BLUE BIRD

R09PB

SUBJECT: RECALL R09PB BATTERY POWER CABLE ROUTING

Battery Cable Routing **RECALL**

PDU pulled outward at right side to gain access to cables at rear of engine

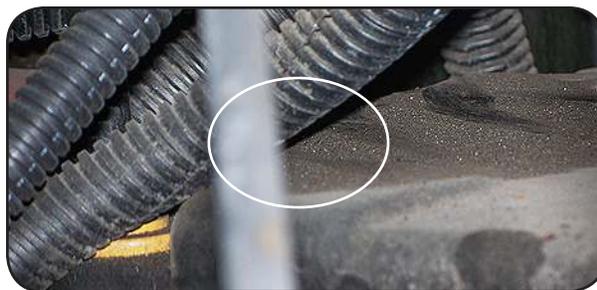
7.1 Remove the fasteners which mount the PDU. Carefully slide the right side of the PDU rearward far enough to view the wiring behind the engine.

7.2 Locate the two button-head cable ties which secure battery cables to the PDU. If either of the button-head cable ties are broken, missing, or damaged during the removal of the PDU, install new button-head cable ties (0024706) before reinstalling the PDU.

7.3 Inspect the battery cables for any evidence of contact with the rear of the engine, chaffing, or other damage. (Some harnesses may be attached to the engine lifting eye; those are not battery cables.)

- If no damage is evident, and the required 1/2" minimum clearance is provided, proceed to step 8.
- If clearance between the cable(s) and any part of the engine is less than 1/2", perform **Sub Procedure A: Cable Protector Installation**.

Area of possible cable damage against front edge of transmission cover plate

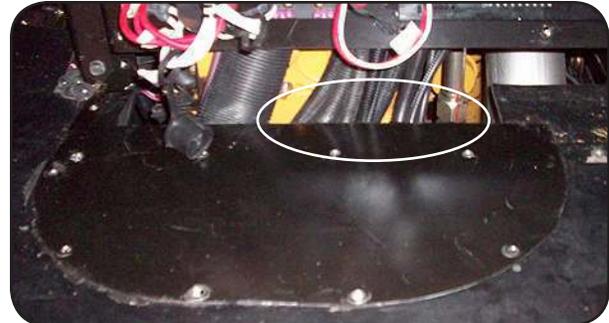
7.4 Inspect all the harnesses passing under the front edge of the transmission cover, as follows:

- If no contact between the transmission cover and harnesses is evident, proceed to step 8.
- If any evidence is found of chaffing or other damage due to contact against the transmission cover, perform **Sub Procedure B: Relocate Transmission Cover**.

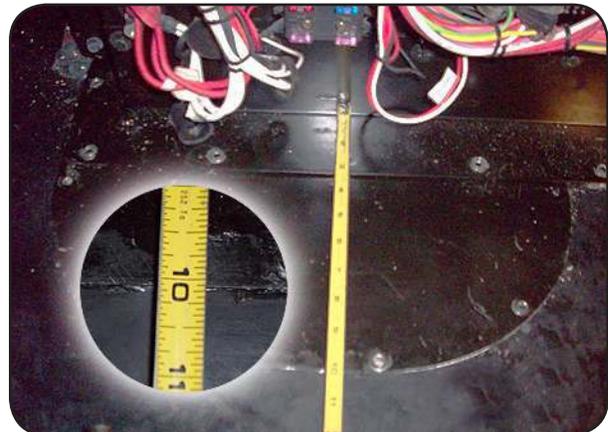
1 If any evidence of cable loom contact with the engine, chafing, or other damage is evident, or if clearance between the battery cable(s) and any part of the engine is less than the required minimum 1/2" but cannot be repositioned, inspect further to determine the extent of damage:

- If the loom has been rubbed, but no damage to the battery cable inside has occurred, then install cable protector (BB # 0040818) between the engine and battery cable. Wrap the protector around the cable loom and secure it with two Cable Ties (BB # 0029999) as shown below.
